DASY8/6 Module WPT

PIA INQUIRY

PIA Inquiry: Compliance Testing against SAR and MPE Limits with DASY8/6 Module WPT

**A Response to FCC's Questions/Comments about KDB Inquiry 959118
(Apr. 3, 2024)**

Figure 1: Module WPT procedure for validation and assessment of the uncertainty of the field reconstruction.

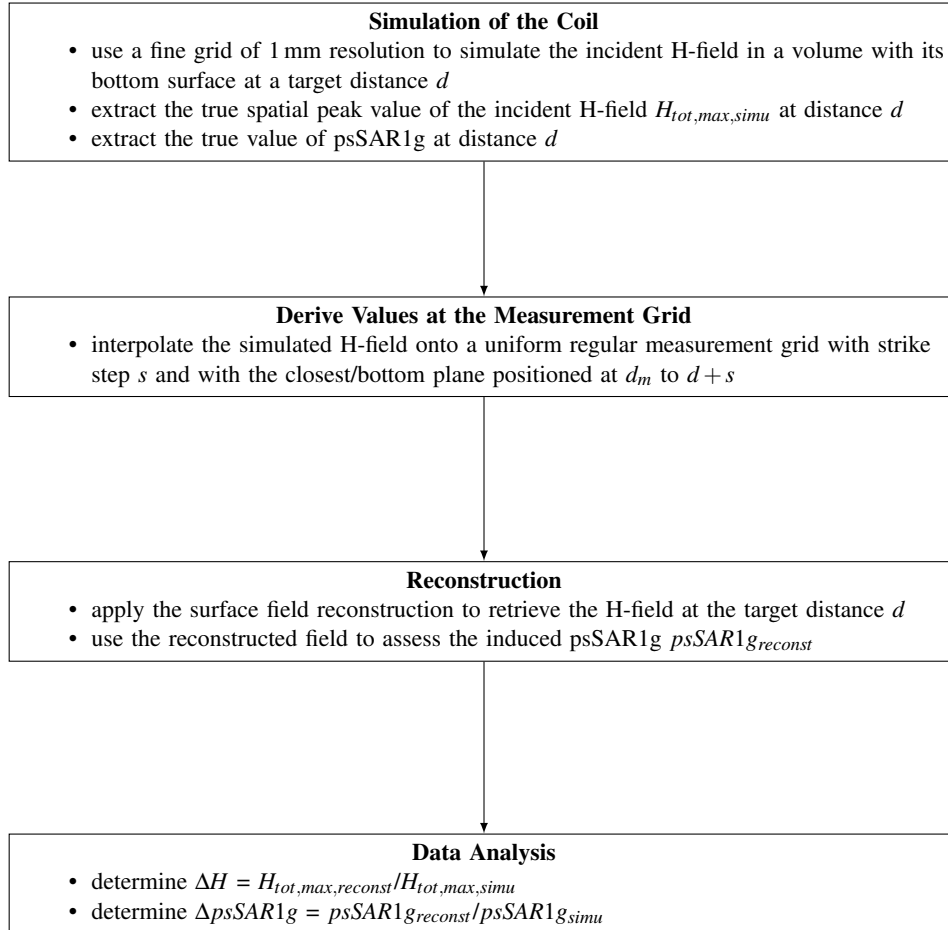
This surface H-field reconstruction has been validated as documented in Appendix A. The assessed uncertainty is 0.6 dB ($k = 2$), and the full uncertainty budget is provided in Section 6.2 of the Module WPT manual [3].

The surface field reconstruction method has been validated for different distances from the coil by comparing the H-field and induced SAR reconstructed on the basis of values simulated on a uniform regular measurement grid to the values determined from simulations. The diameter of the coil geometry is varied from 50 mm to 450 mm, and the filling ratio ranges from 0.1 to 0.9. The detailed assessment workflow is illustrated in Figure 1.

Figure 2: H-field probe with pickup loops of diameter d for the three vector components above the windings of a WPT coil. The probe tip touches the cover of the WPT system and is located at distance z_0 from the coil. The probe reference location is in the probe center at $0.5d + z_0$.

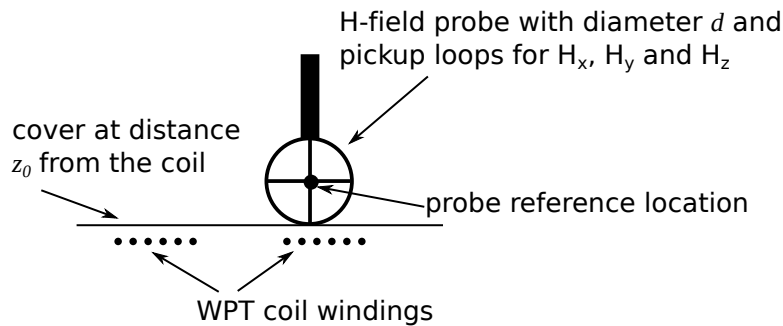
While we expect that this measurement will work quite well for coils that provide a relatively uniform field along the axis over a characteristic length in the order of the radius of the probe, it would be interesting to see what could be a more challenging case for smaller coils, where the field lines are expected to exhibit a more pronounced to turn off-axis, even at the small distance of the probe radius.

In other words, let's consider r the radius of the probe, R the radius of the coil located in $z=0$ with z being the direction of the coil axis; one can measure the field exactly by placing the center of the probe at $z=r$, and extrapolate the field at $z=0$ (contact position with the coil plane). If $R \gg r$, then the field lines will be relatively "straight" at $z=r$. But if $R \approx r$, the curvature of the field lines will be more pronounced, and one would expect a lesser accuracy of the field estimate at $z=0$.

Figure 2 shows a probe with three pick-up loops measuring the H-field at distance d above the cover of a WPT system. The deviation of the measured field integrated over the areas of the three loops from the actual H-field maximum at the cover of the WPT system for the 70 different generic WPT coils evaluated in [2] is given in Figure 3 as a function of the probe diameter. The errors of the 70 different cases is normalized to the mean value for their respective radii. The mean values are given as figures in the plots below the respective error distributions. The deviations of a gradient probe, which uses a pick-up loop with 5 mm radius for the measurements of surface fields, are given for comparison [2]. This has already been evaluated in [9]. The required measurement distance of $1.7 \times$ the probe diameter cited in [9] greatly reduces the uncertainty of the measurements but does not allow evaluation of the exposures at smaller distances with reasonable uncertainty.

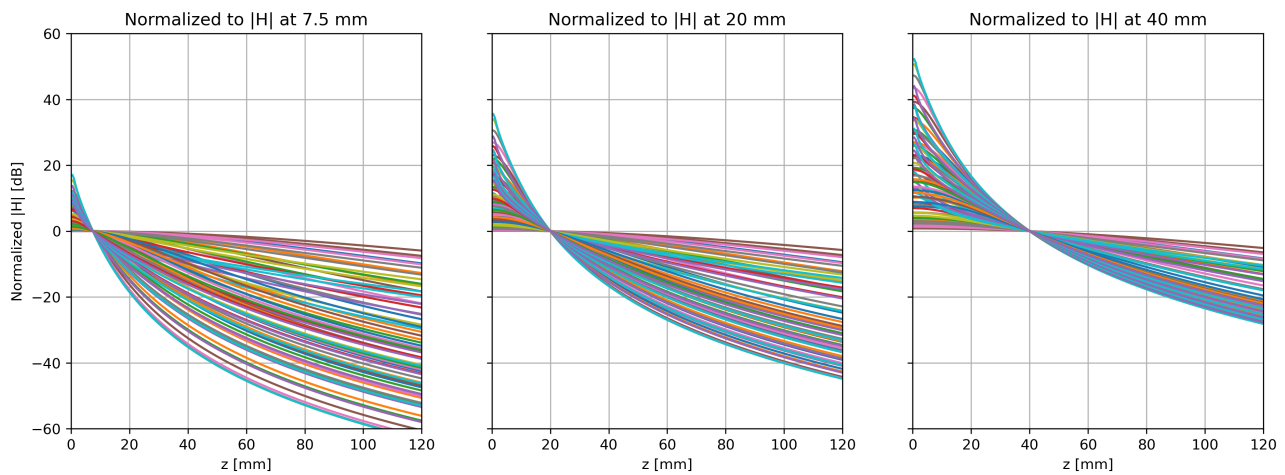
We outlined in the previous reply the validation of the extrapolation method (that is, using the probe without the field reconstruction), and we expanded that in more detail in the latest Apr 2024 TCBC workshop (Presentation 4.2).

Figure 1 shows that if we are able to measure the field accurately at 20 mm, the field at the surface is between 0 dB and 38 dB (1–80 times) of the value at 20 mm. If the field is accurately measured at 7.5 mm, the variation is reduced to 0 dB and 17 dB (1–7 times) of the value at 7.5 mm. In other words, the measurement at 7.5 mm is not sufficient to determine the field at the surface with an uncertainty of $\pm 30\%$ as requested by FCC [1].

We believe that the procedure meets the FCC criteria of $\pm 30\%$. It has been validated using several thousands different realistic H-field decays/profiles.

If we would measure as suggested at 7.5 mm and take another measurement with an offset of 7.5 mm (i.e., at 15 mm from the surface) and use this information to find an optimal extrapolation function to estimate the field at the surface, the results would be more accurate since the gradient would be more accurate. However, the final uncertainty would be prone to user errors and affected by the uncertainty of the 7.5 mm shift.
